NOTICE OF MEETING
PLANNING COMMISSION
CITY OF ST. GEORGE
WASHINGTON COUNTY, UTAH

**ZONE CHANGE &
DEVELOPMENT AGREEMENT**

Zone Change & Development Agreement

2023-ZC-006 & 2023-DA-003

Proposed Site Plan

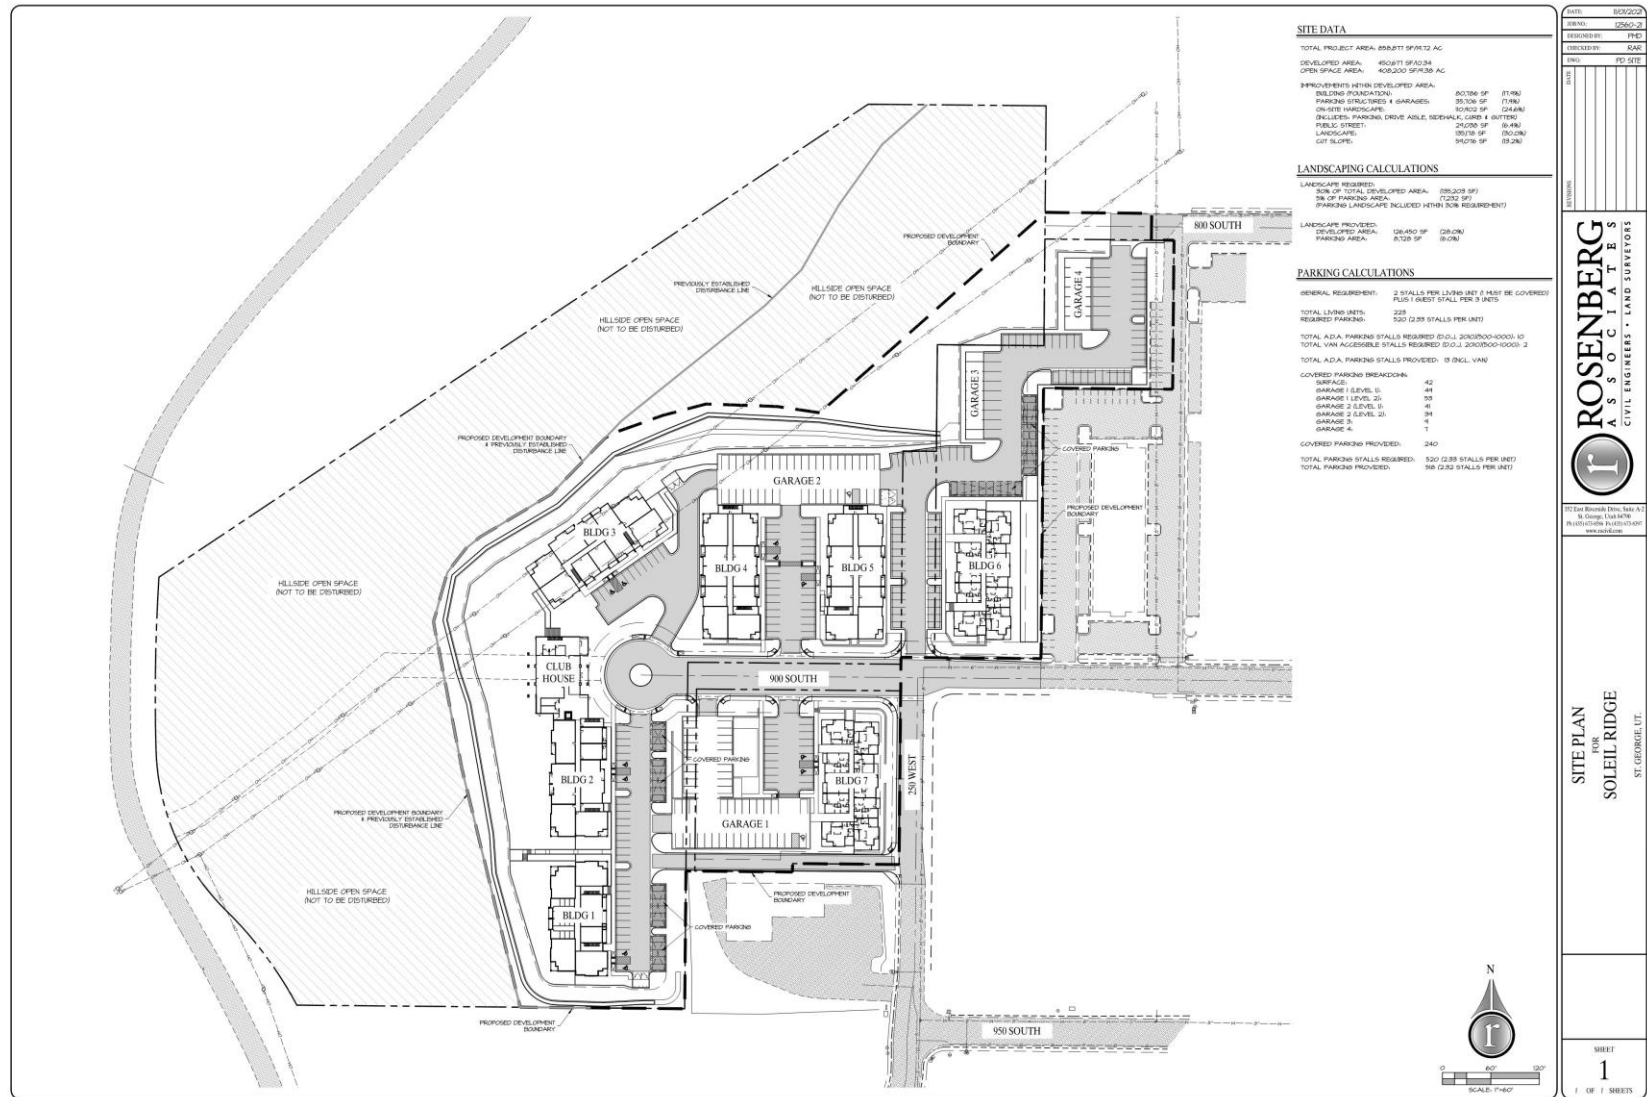
City Parcel: There is an approximately 395'x11' "sliver" parcel that is owned by the city on the southern portion of the site. The site plan shows a portion of a structure that overlaps that parcel. The City has worked with the applicant on this issue. It was a parcel that was handed over to the city from the County. Through the development agreement, the city will turn that over to the applicant in exchange for seven units that will meet the affordable housing standards.

Parking Structure Elevations

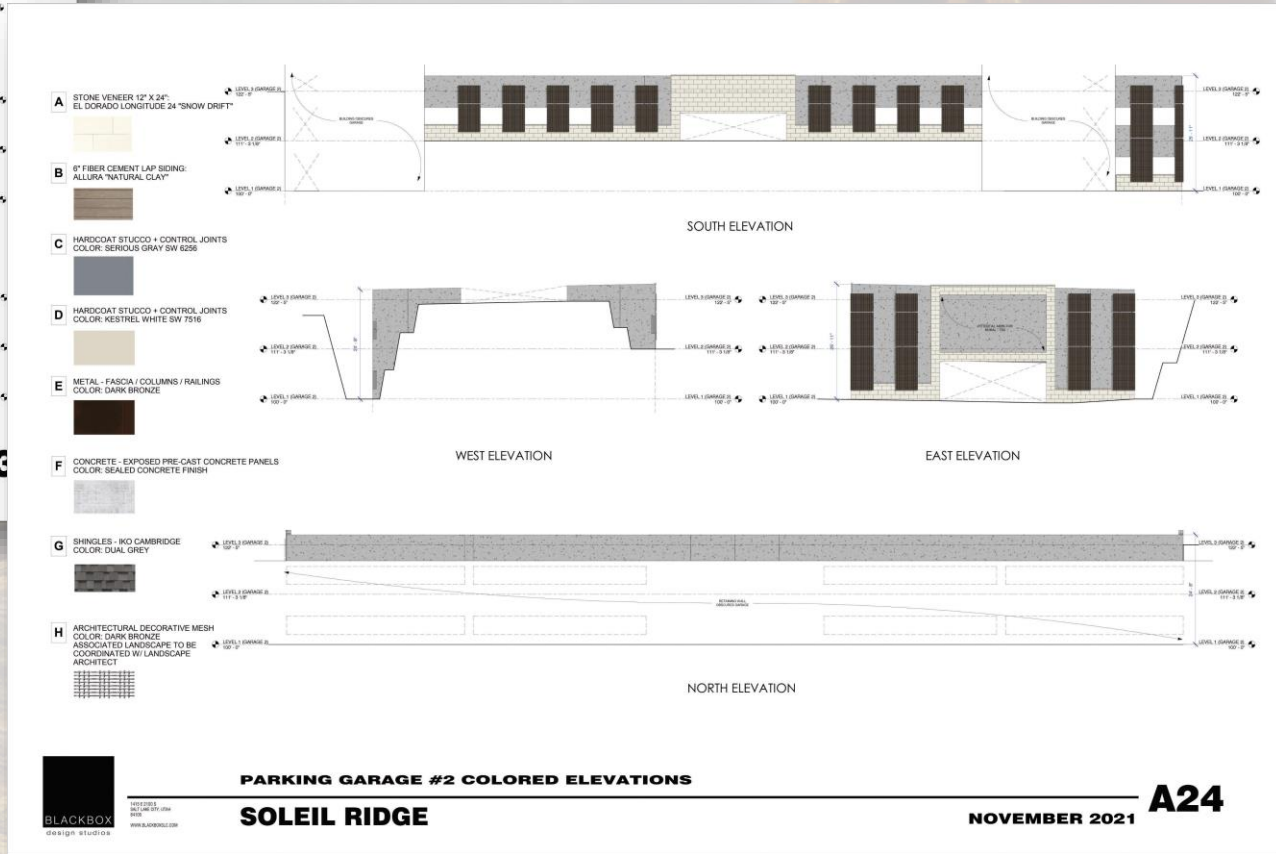
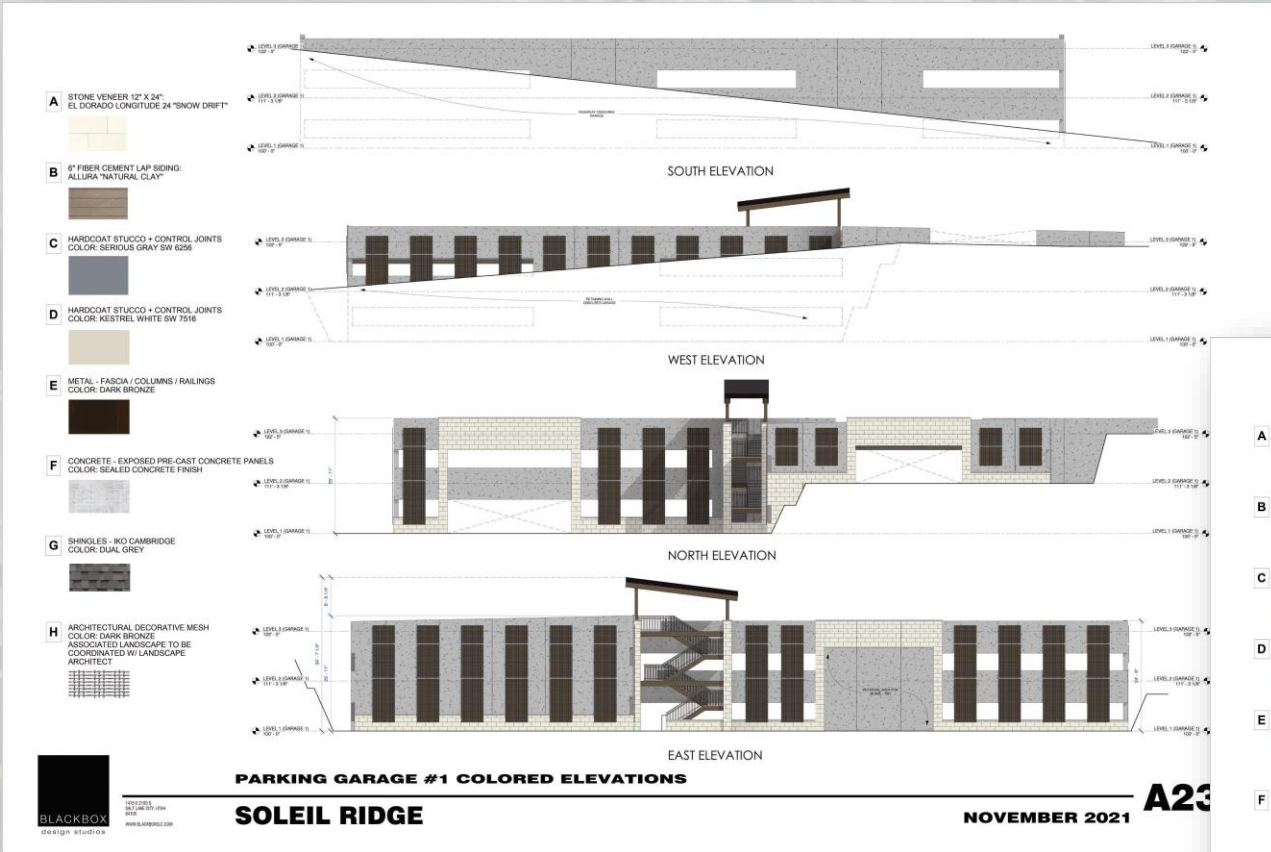
2. *Additional detail on the parking structure on their elevations, inside and outside the property.* The applicant has revised the parking structure to add additional detail such as stone that would tie the structure to the buildings. See updated elevations in the presentation attached to this staff report.

Part of the proposal for the parking is incorporating two parking structures. Those parking structures are concrete which is to be expected. However, staff is concerned with the appearance of plain concrete parking structures. Staff is suggesting that they make improvements through change of materials and/or coloring and stamping the concrete to provide visual interest. The applicant is also proposing smaller garages on the northern portion of the property. Any garages must be open to all residents and guests and may not be charged by the owner.
